A2. Well and aquifer data:

B. BASIN PROGRAM:

C. WATER AVAILABILITY:

Well Location Map

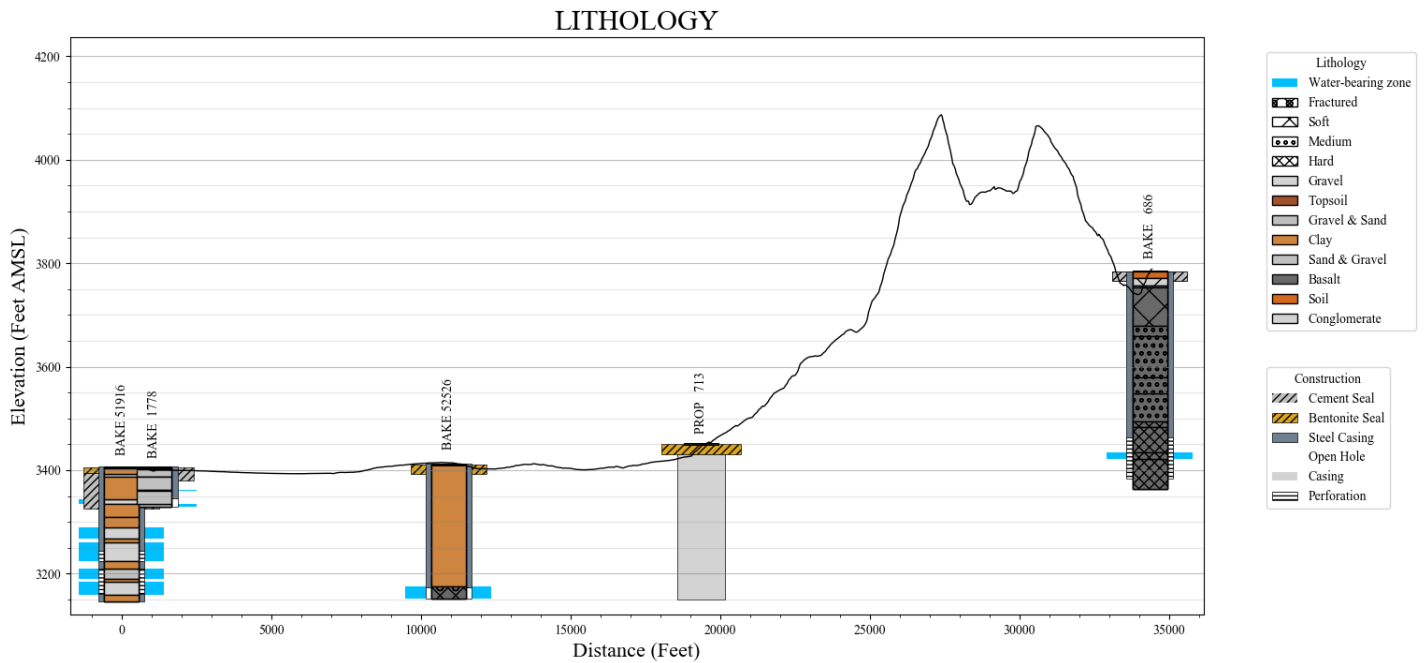
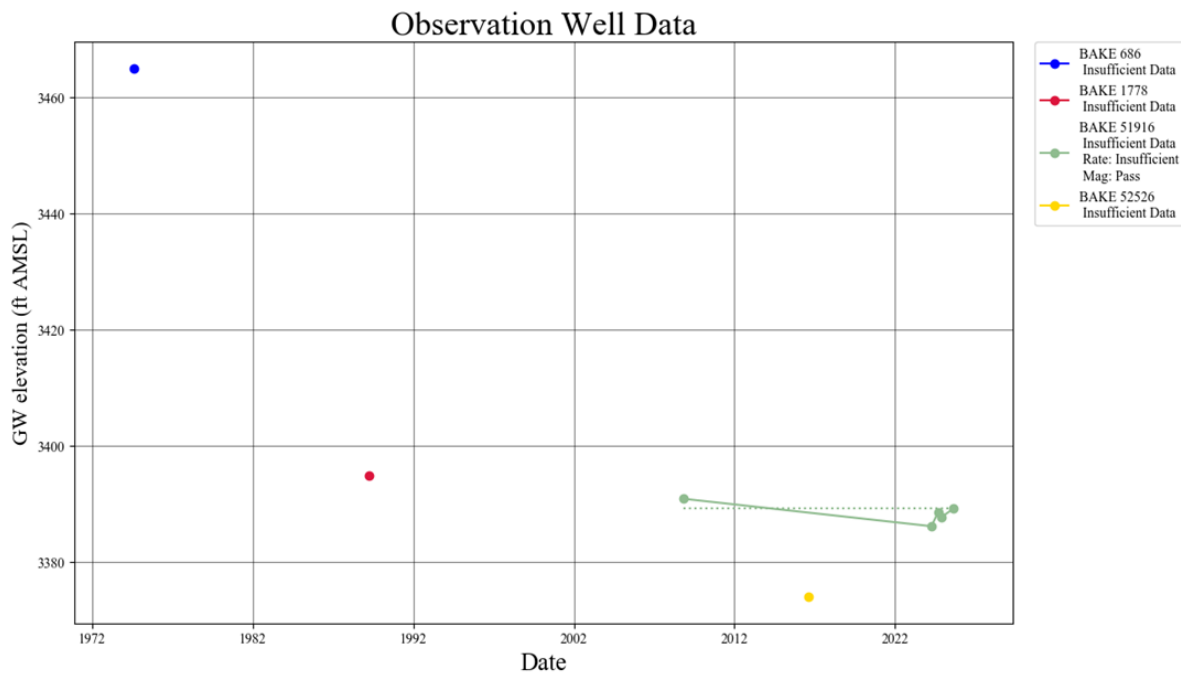
Comments: Application G-19493 requests a total of 2.5 cfs (1,122gpm) from up to 3 wells, requiring each well to produce a minimum of 374 gpm. In the well log database, 20 well logs were found in the following sections: T8S/R41E Sections 19,30,31,32; T8S/R40E Section 36; T9S/R40E Section 1; T9S/R41E Sections 6,7. Reported well yields range from 0 to 400 gpm, with a median yield of 40 gpm. This may be biased low due to the fact that many nearby wells are for domestic uses, however it is still an order of magnitude lower than the approximately 375 gpm per well that the application seeks.

Comments: The proposed POA wells will produce from either volcanic rock (presumably Basalt of Little Catherine Creek or Andesite of Sawtooth Crater), granite, or metamorphic rock. In any case, these bedrock units are truncated by local geologic structures at the fringe of the Baker Valley by basin-bounding faults. In our conceptual model, saturated transmissive horizons (volcanic rock) or fracture zones (intrusive or metamorphic rock) are in direct contact with adjacent saturated alluvial materials, which are hydraulically connected to the Powder River. While there is no analytical model suitable for modeling stream depletion in fractured rock aquifers, the water produced at the proposed POA wells would come from the groundwater flow system upgradient of the Powder River. Water pumped from the wells would represent capture per Barlow and Leake (2012), meaning water diverted by the wells would otherwise discharge to downgradient reaches of the Powder River. Under OAR 690-008-0001 definitions, any stream depletion will result in PSI. There is no water available in Watershed ID 243 in any month of the year.

Comments: In these proposed locations, groundwater movement is achieved primarily through unevenly spaced secondary fractures having random orientations. As a result, these systems are quite heterogeneous in terms of productivity and both horizontal and vertical hydraulic conductivity. Based on this conceptual model, there is no appropriate analytical model to predict drawdown at adjacent wells. In a fractured rock aquifer with characteristically low transmissivity, the cone of depression created by a pumping well is expected to be narrow and deep. There are no groundwater POAs located within 1 mile of the proposed POAs, meaning direct well-to-well interference is unlikely.
